SUBDIVISION STAFF REPORT Date: January 22, 2004

<u>DEVELOPMENT NAME</u> Credit America Used Car Sales Subdivision,

SUBDIVISION NAME Credit America Used Car Sales Subdivision,

LOCATION Northeast corner of Spring Hill Avenue and Union

SITE PLAN

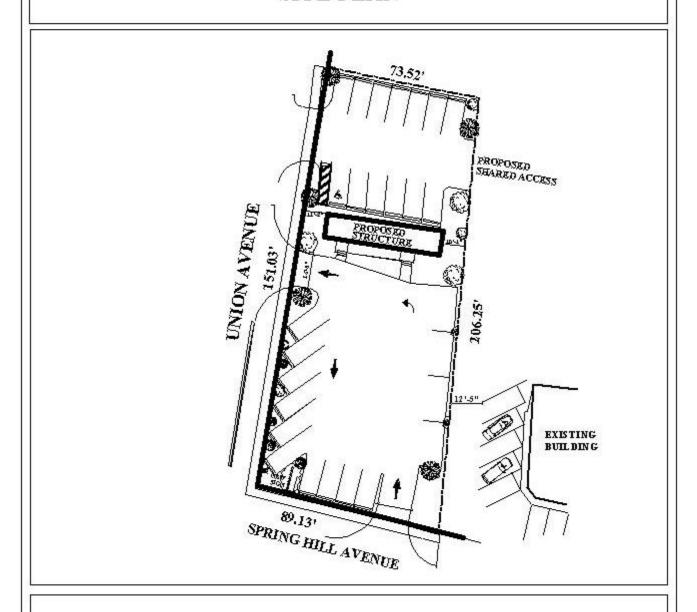
Prior to the demolition of an existing building at the northwest corner of Springhill Avenue and Union Avenue, the two sites had cross access. A new building for the northwest corner is proposed, and the PUD application would allow shared access between the two sites. As illustrated on the site plan, this access would be via the parking lot to the North. The site plan does not illustrate all of the easternmost lot; however, with the exception of a pecan tree and the existing building, the entire site to the east is asphalt.

The existing developed property (to the east) has parking in front of the building that backs into Springhill Avenue. Backing into major street traffic poses a hazard, thus these parking spaces should be removed and the area landscaped. The remainder of the parking is angled along the west side of the building with a 12.5-foot wide, one-way, aisle to access the parking lot to the rear. Because there is inadequate room for two-way traffic, the connection between the two lots is critical. However, the parking lot for the existing development is not striped and cars park somewhat randomly, thus all parking spaces on the eastern lot should be striped.

The site received Tentative Approval as a one-lot subdivision in October 2003 and a condition of approval limited the site to one curb cut to Union Avenue. Based upon the attached site plan, the applicant is requesting a second curb cut to Union Avenue.

RECOMMENDATION Planned Unit Development Approval: Based upon the preceding, this application is recommended for approval subject to the following conditions: 1) that the parking spaces (on the eastern site) that back into Springhill Avenue be removed, and the area landscaped; 2) the striping of the parking areas; 3) full compliance with the landscaping and tree planting requirements for the newly developed site located at the Northeast corner of Springhill Avenue and Union Avenue; and 4) full compliance with all municipal codes and ordinances.

Subdivision: The plat meets the minimum requirements of the Subdivision Regulations and is recommended for Tentative Approval subject to the following condition: 1) placement of a note on the final plat stating that the location, number and design of all curb cuts shall be approved by Traffic Engineering.
